Access Compliance Report

Public Rights-of-Way

(Pedestrian Signals)

Intersection ID: N/A	Main Street:	Cross Street: N/A	Location: N/A
ADA ID: ACF4B77F9DD5	Signal Type: One Push Button-Non APS	Overall Compliance: No	Severity Score: BTN 1: N/A BTN 2: N/A No BTN: N/A
Codes/Mitigation Info/Possible Solution		Field Measurements/Component Compliance

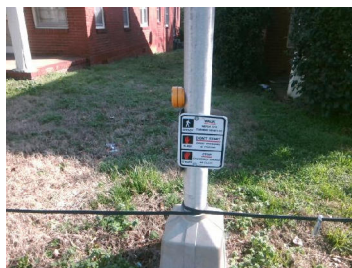
PROW/ADA: TMUTCD 4e.08, R404.3, R404.2, R404.7.3, R404.7.2

N/A	B 1 FWD Approach Width (in)	N/A	N/A	B 2 FWD Approach Width (in)	N/A
N/A	B 1 FWD Approach Obstruction?	Yes	N/A	B 2 FWD Approach Obstruction?	N/A
N/A	B 1 FWD Approach Obstruction Dist (in)	5.0	N/A	B 2 FWD Approach ObstructionDist (in)	N/A
N/A	B 1 PARA Approach?	Yes	N/A	B 2 PARA Approach?	N/A
N/A	B 1 PARA Approach Constrained?	Yes	N/A	B 2 PARA Approach Constrained?	N/A
No	B 1 PARA Approach Reach (in)	24.0	N/A	B 2 PARA Approach Reach (in)	N/A
No	B 1 PARA Approach Width (in)	48.0	N/A	B 2 PARA Approach Width (in)	N/A
N/A	B 1 PARA Approach Obstruction?	Yes	N/A	B 2 PARA Approach Obstruction?	N/A
N/A	B 1 PARA Approach Obstruction Dist (in)	6.0	N/A	B 2 PARA Approach ObstructionDist (in)	N/A
No	B 1 Clear Floor Space Slope (%)	3.1	N/A	B 2 Clear Floor Space Slope (%)	N/A
No	B 1 Clear Floor Space XSlope (%)	2.4	N/A	B 2 Clear Floor Space XSlope (%)	N/A
N/A	B 1 PAR Slope (%)	N/A	N/A	B 2 PAR Slope (%)	N/A
Yes	B 1 Height (in)	38.0	N/A	B 2 Height (in)	N/A

N/A	B 1 Clear Xing Direction?	Yes	N/A	B 2 Clear Xing Direction?	N/A
	B 1 Crossing Direction	To SW		B 2 Crossing Direction	N/A
Yes	B 1 DistanceTo XWalk (in)	0.0	N/A	B 2 DistanceTo XWalk (in)	N/A
No	B 1 DistanceTo Curb (in)	88.0	N/A	B 2 DistanceTo Curb (in)	N/A
Yes	B 1 Diameter (in)	2.0	N/A	B 2 Diameter (in)	N/A

Possible Solutions: Replace Signal Push Button With APS Button on New Post. Remove & Relocate Sign.
